Access Compliance Report

Public Rights-of-Way

Intersection ID: 44419	Main Street: ARDREY_KELL_RD	Cross Street: PROVIDENCE_RD	Location: NE
ADA ID: 10773E289612	Ramp Type: Perp	Initial Pass/Fail: Pass	Overall Compliance: No
Severity Score: 0			
Codes/Mitigation Info/Possible Solution		Field Measurements/Component Compliance

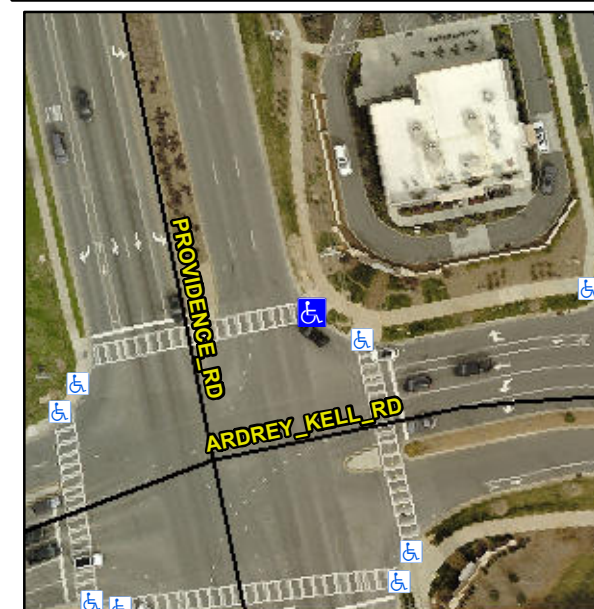
R304.2.2-Perp, R304.3.2-Para, R305.2

Compliance	Description	Data	Compliance	Description	Data
N/A	Ramp Length (in)	97.0	Yes	Ramp Slope (%)	6.5
Yes	Ramp Width (in)	48.5	Yes	Ramp XSlope (%)	1.7
N/A	Flare Type LT	Sloped	N/A	Flare Type RT	N/A
N/A	Flare Slope LT (%)	7.0	Yes	Flare Slope RT (%)	5.9
N/A	Flare Traversable LT?	Yes	N/A	Flare Traversable RT?	Yes
Yes	Landing Length (in)	79.0	Yes	DWS Provided?	Yes
Yes	Landing Width (in)	48.5	Yes	DWS Contrast?	Yes
No	Landing Slope (%)	2.1	Yes	DWS Length (in)	24.0
Yes	Landing X Slope (%)	0.6	Yes	DWS Full Width?	Yes
N/A	Landing Curb? (Y/N)	No	No	DWS Offset (in)	2.5
N/A	Shared Landing?	No			
Yes	Gutter Ponding?	No	Yes	Gutter Slope (%)	2.8
Yes	Gutter Lip Ht (in)	0.0	Yes	Gutter X Slope (%)	0.5
N/A	Painted X Walk1?	Yes	N/A	Painted X Walk2?	N/A
	X Walk 1 Direction	To W		X Walk 2 Direction	N/A
N/A	X Walk 1 Width (in)	110.0	N/A	X Walk 2 Width (in)	N/A
	X Walk 1 Slope (%)	4.6		X Walk 2 Slope (%)	N/A
	X Walk 1 X Slope (%)	1.0		X Walk 2 X Slope (%)	N/A

Yes	Ramp inside XWalk1?	Yes	N/A	Ramp inside XWalk2?	N/A
	Road Slope (%)	N/A	N/A	Clear Space?	Yes
	Road X Slope (%)	N/A	N/A	Clear Space to XWalk (in)	N/A
Yes	Any Obstructions?	No	Yes	Storm Grate/Utility Hazard?	No
	Obstruction Type			Storm Grate/Utility Type	
		N/A			N/A
			Yes	Surface Condition? (G/P)	Good

Remove & Replace Entire Ramp.
